SUBARU

SERVICE BULLETIN

APPLICABILITY: 2013MY BRZ

SUBJECT: Countermeasures for Frozen Power Windows

Guide Door Lifter Service Procedure

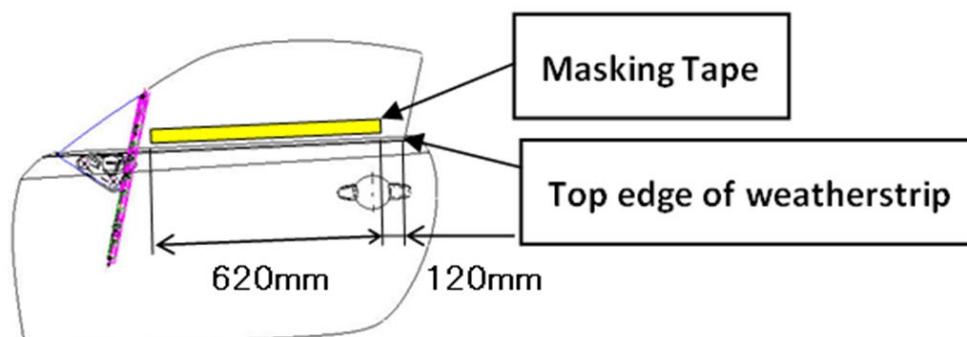
IMPORTANT: The guide door lifters **must** be replaced at the same time the countermeasure power window switches are installed. See the comparison illustration below.

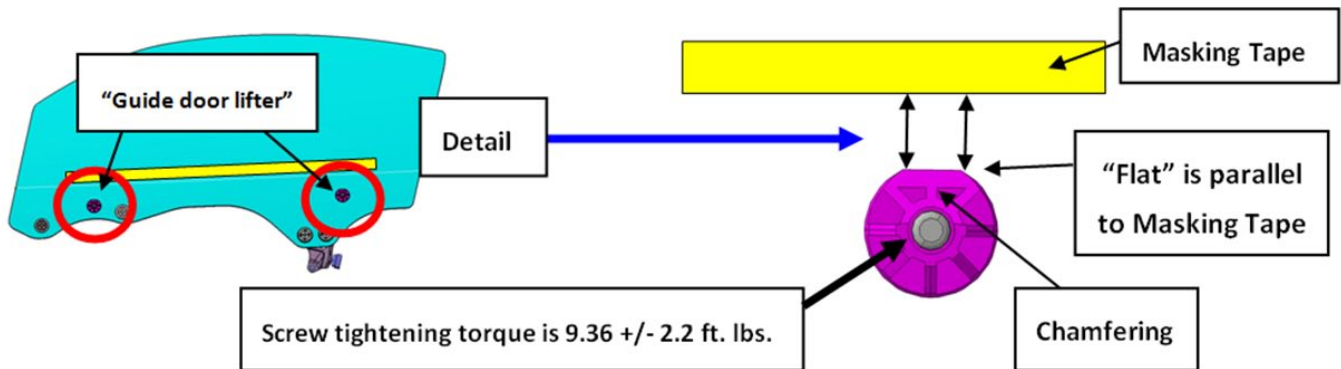
- With the door and the door glass fully closed, use masking tape to “mark” the position of the glass in relation to the outer weatherstrip top edge as shown in the illustration below.

- **Carefully** remove both door glass assemblies following the procedures outlined in the applicable Service Manual.
- Remove the old guide door lifters from the door glass assembly and replace with the new parts. The “flats” must be positioned at 12:00 and parallel to the bottom edge of the masking tape as shown in the illustration below. The retaining screws can be reused and get torqued to 9.36 +/- 2.2 ft. lbs. Should any of the screws be misplaced, the replacement part number is 904530039.
